# Technical Service Bulletin

<b>Subject:</b>  REAR BRAKE NOISE	<b>Bulletin No.:</b> 04-001/24
	<b>Last Issued :</b> 03/04/2024

2019-2024 Mazda3 (Japan built)  
2019-2024 Mazda3 (Mexico built)  
2020-2024 CX-30  
2022-2023 MX-30

SECTION A-A

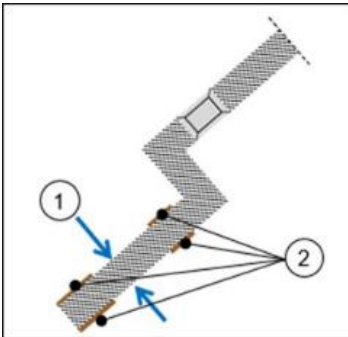
1. Verify the customer concern.
2. Check the disc surface to see if the cause of noise and vibration is the disc's rust (Some areas of the surface have fallen off due to rust and are too thin, which may look like black stains on the surface). If rust is the cause of the noise or vibration when applying the brake, lathе disks on-vehicle, or replace them with new ones and replace the brake pads.

- Check the disc thickness using a micrometer before lathing, if the thickness is below 8.7 mm for 2WD or 9.7 mm for AWD, replace the disc (DO NOT lathе). Measure the thickness in the relatively less rusted area where the pads are hitting but not in the severely rusted area.
- Disc replacement is acceptable if an on-car lathe machine is not available.

Some areas of the surface have fallen off due to rust and are too thin.

**NOTE:** Measure the thickness at the least rusted area.

- (1) Measuring points  
(2) Rust

3. After lathing the disc, re-measure the disc thickness. Replace the discs if the thickness is below the machining limit of 7.8 mm for 2WD and 8.8 mm for AWD as well as the brake pads. Refer to the instructions in MGSS:
